PERCOLATION TESTING

SUBDIVISION Sabus Farms LOT NO. 262 (Twenty-six)

Approved Septic System Plan
Howard County Health Department

BY COPY OF THIS PLAN THE HEALTH DEPT. ACCEPTS THIS MODIFICATION TO THE RECORDED SEPTIC EASEMENT.

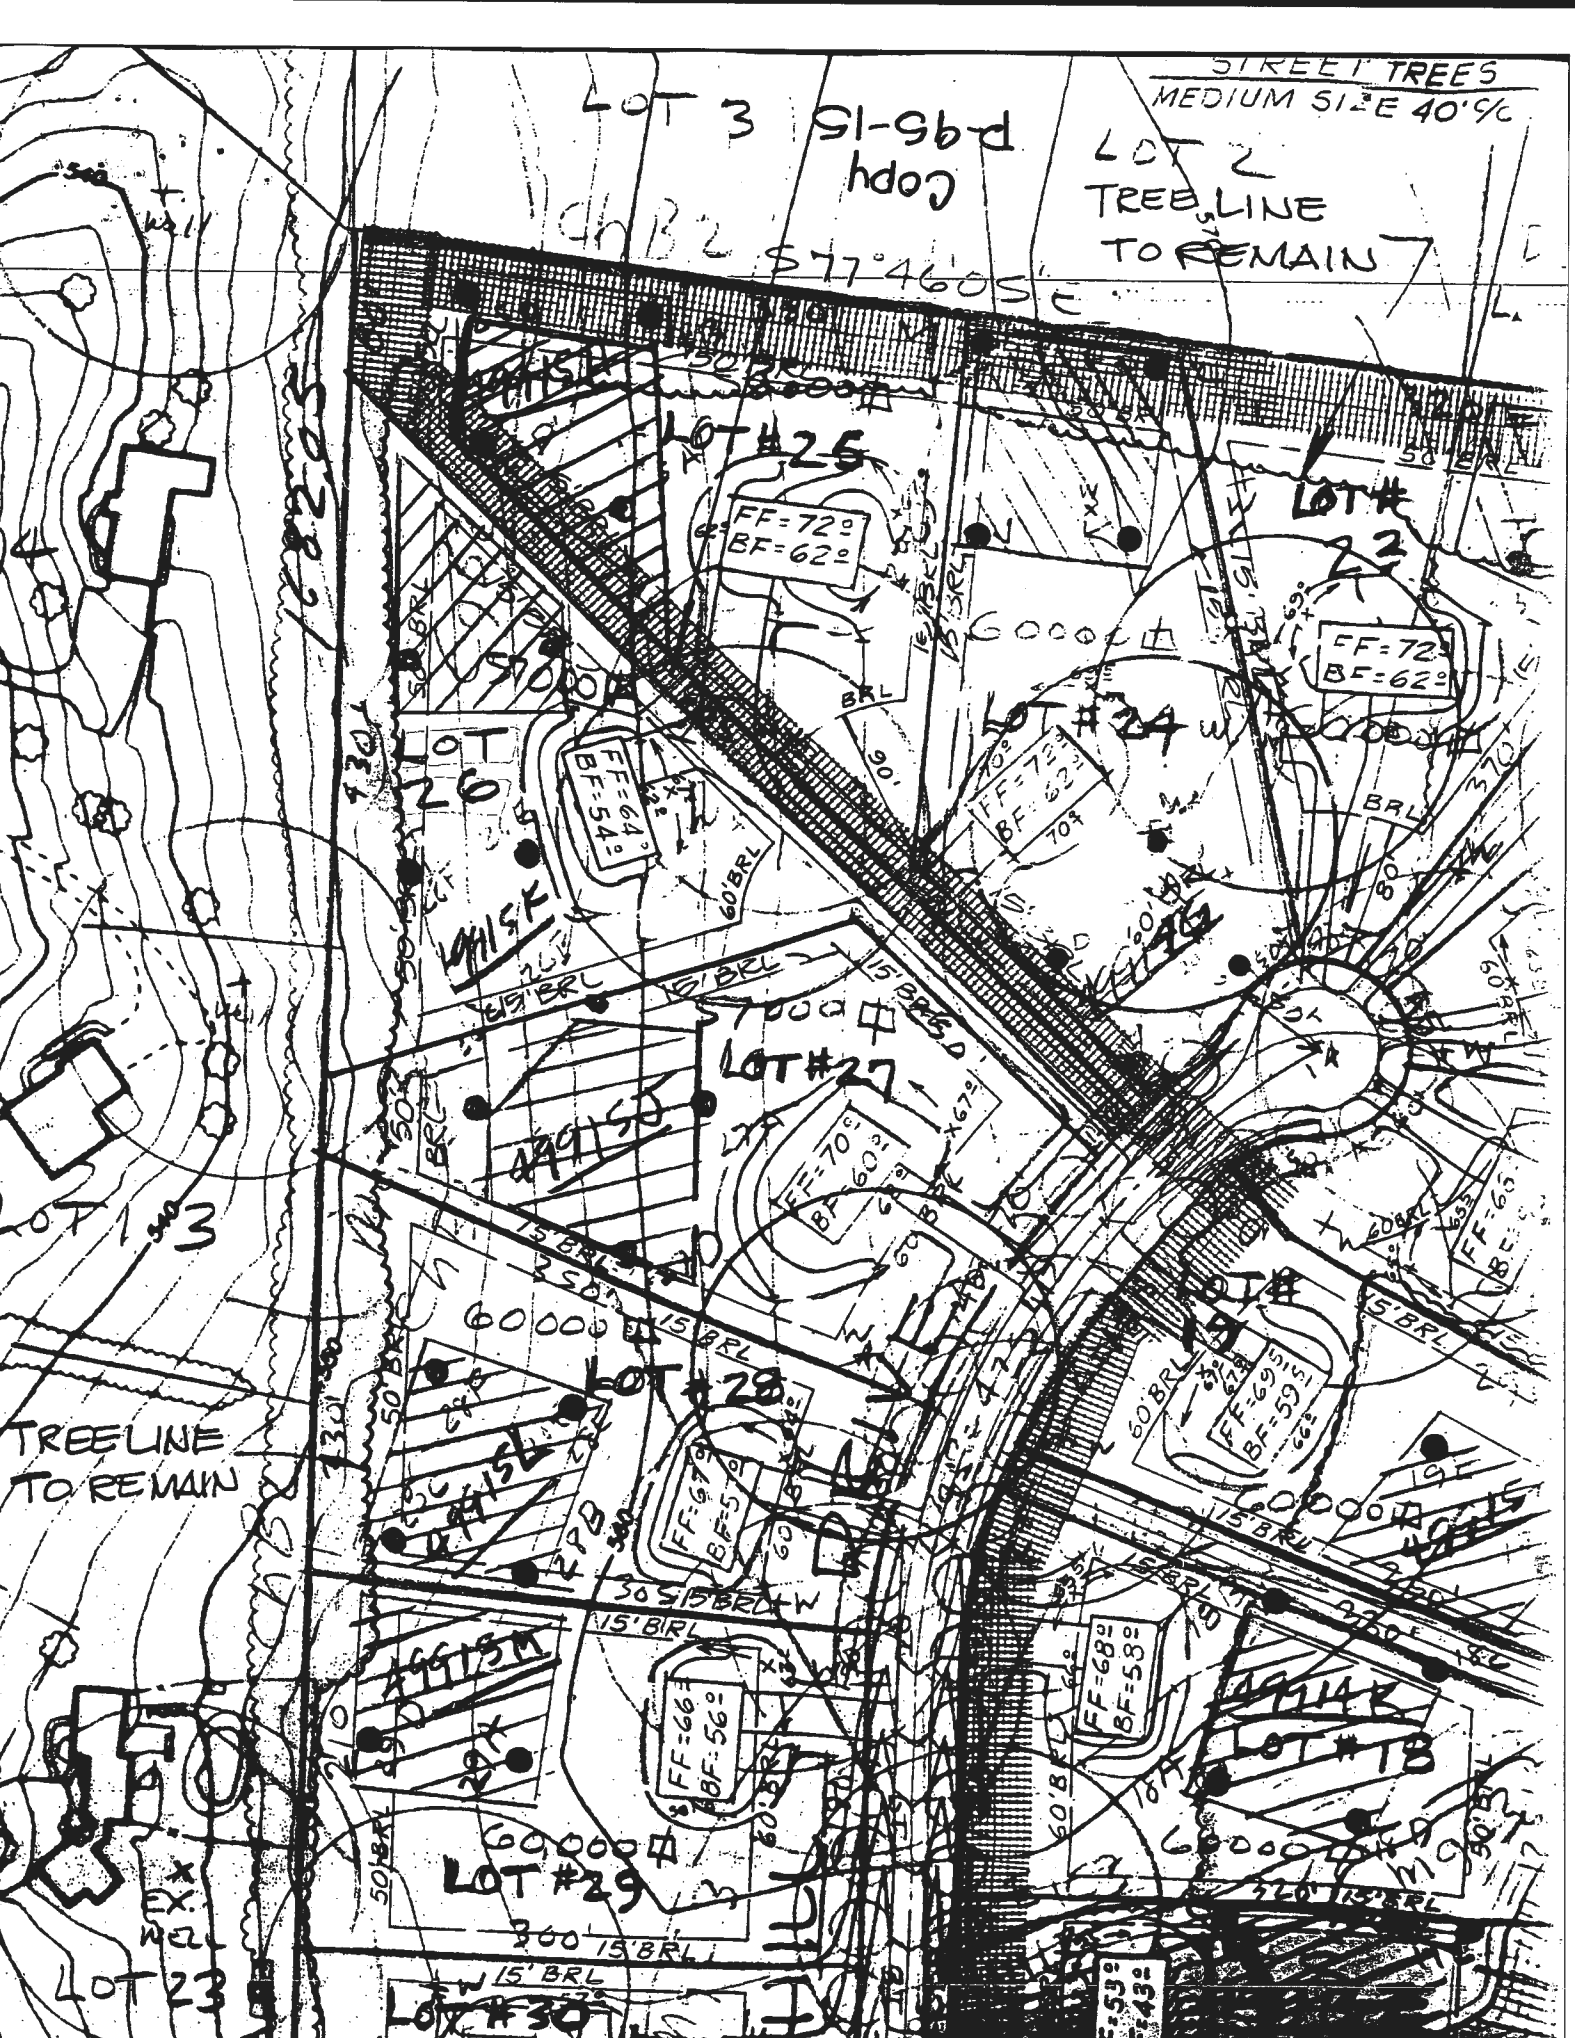
Area to be added
SEPTIC EASEMENT

Area to be deleted

DECK OK *JS*

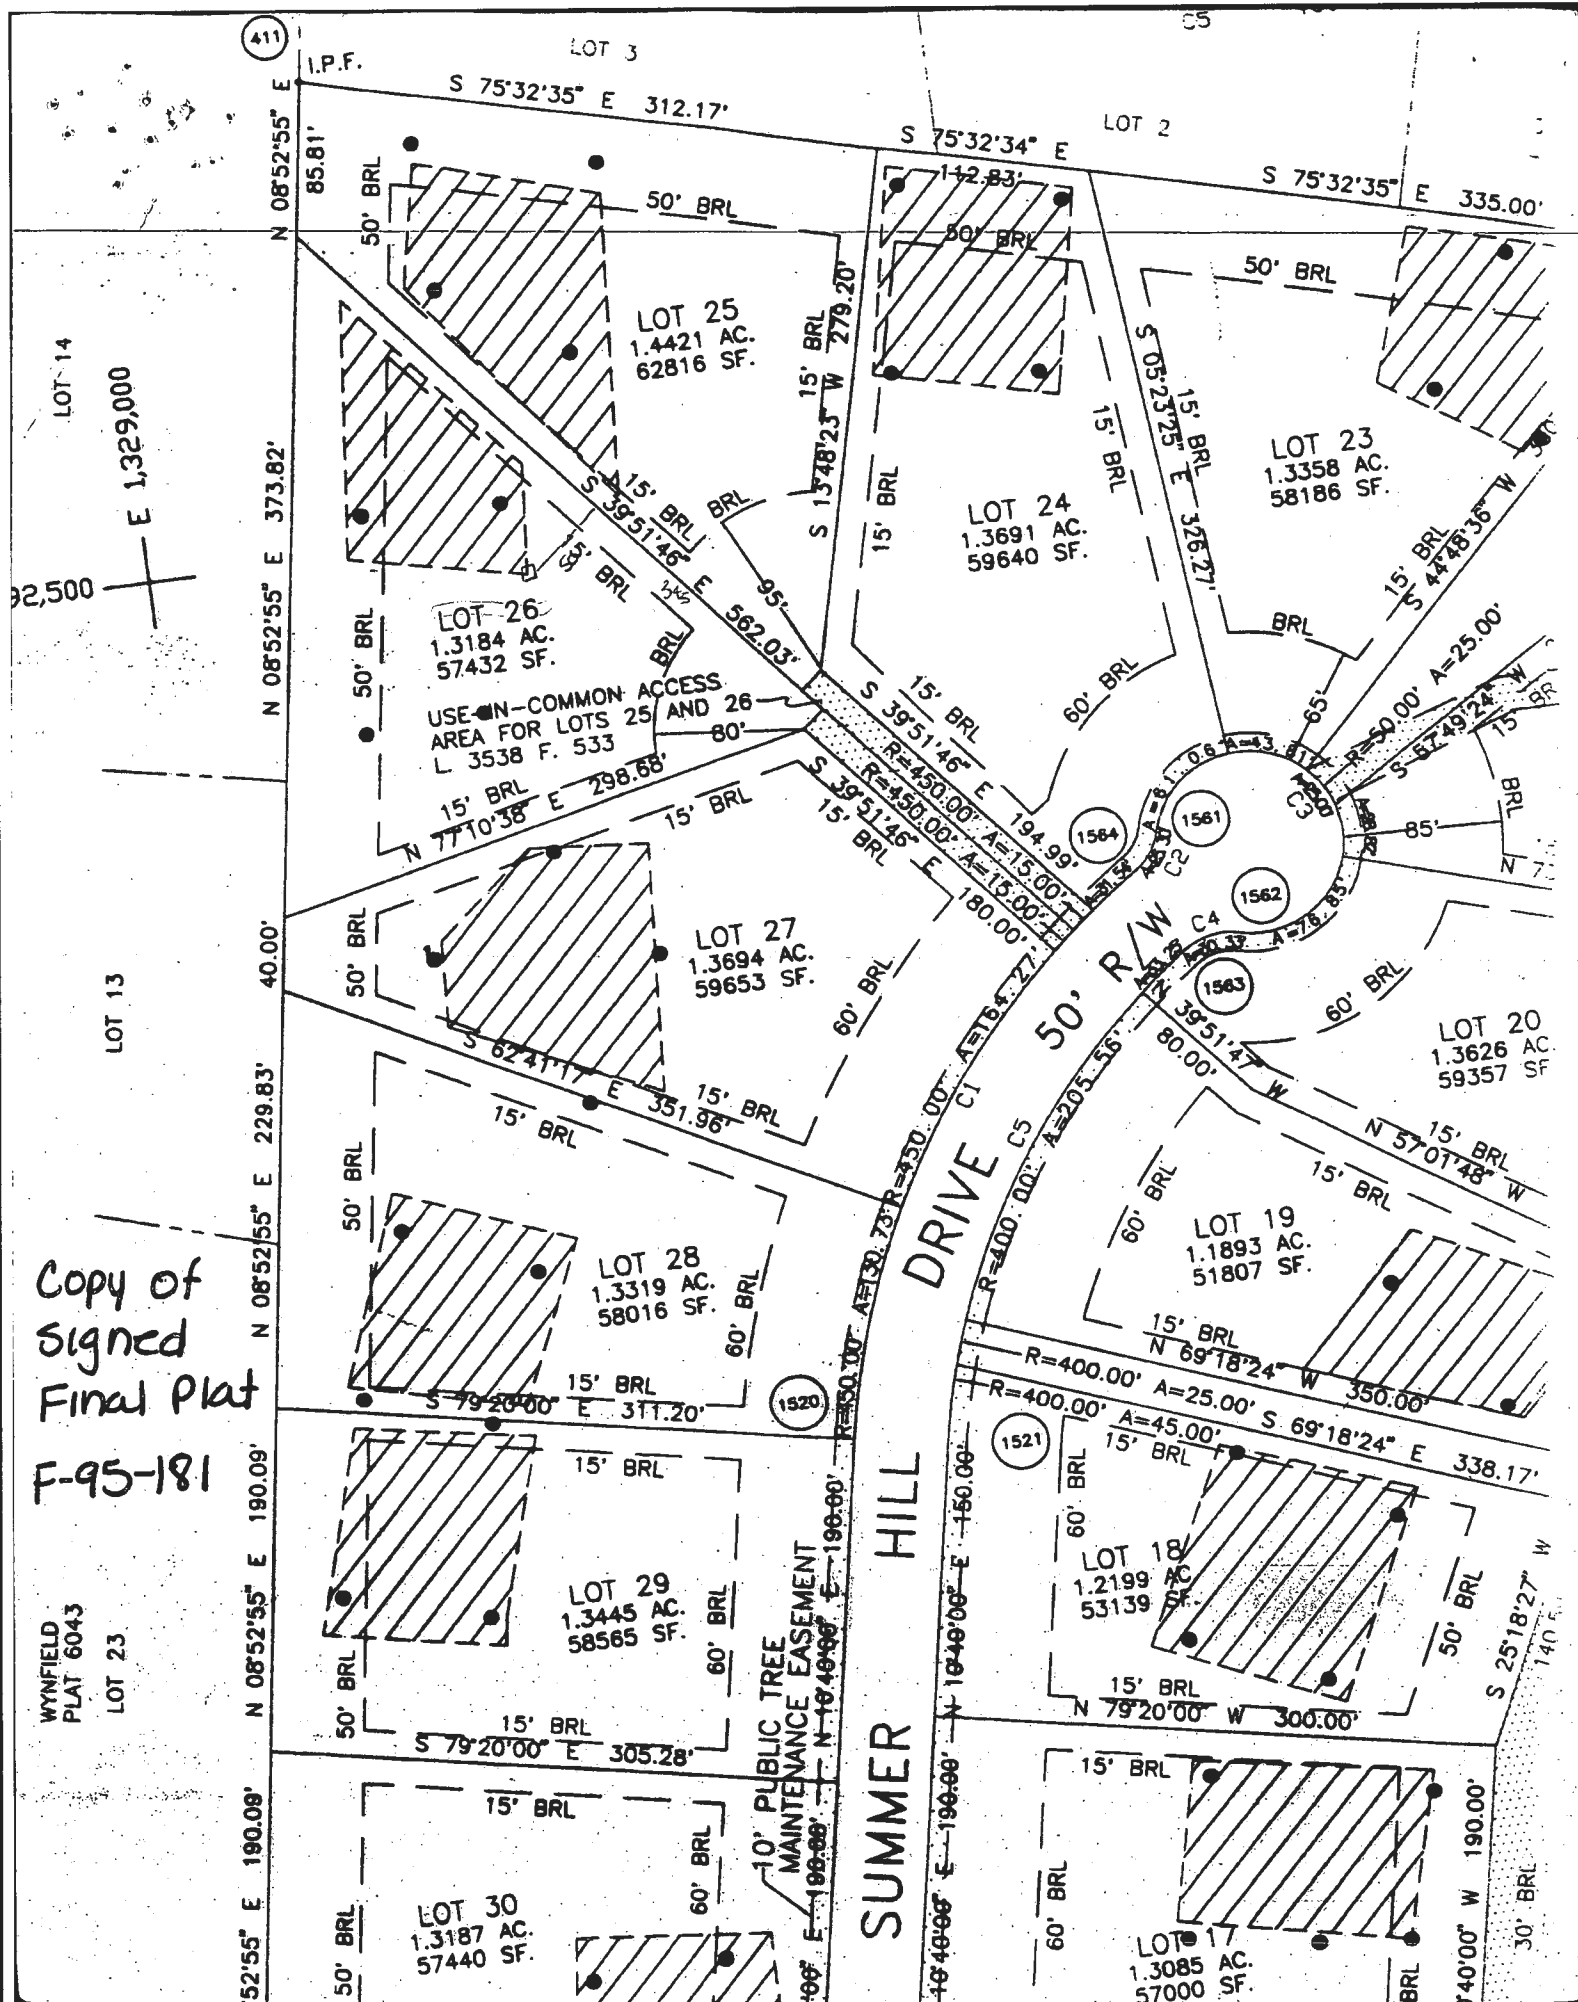
NO OBS. TO
FAMILY ROOM ADD'N
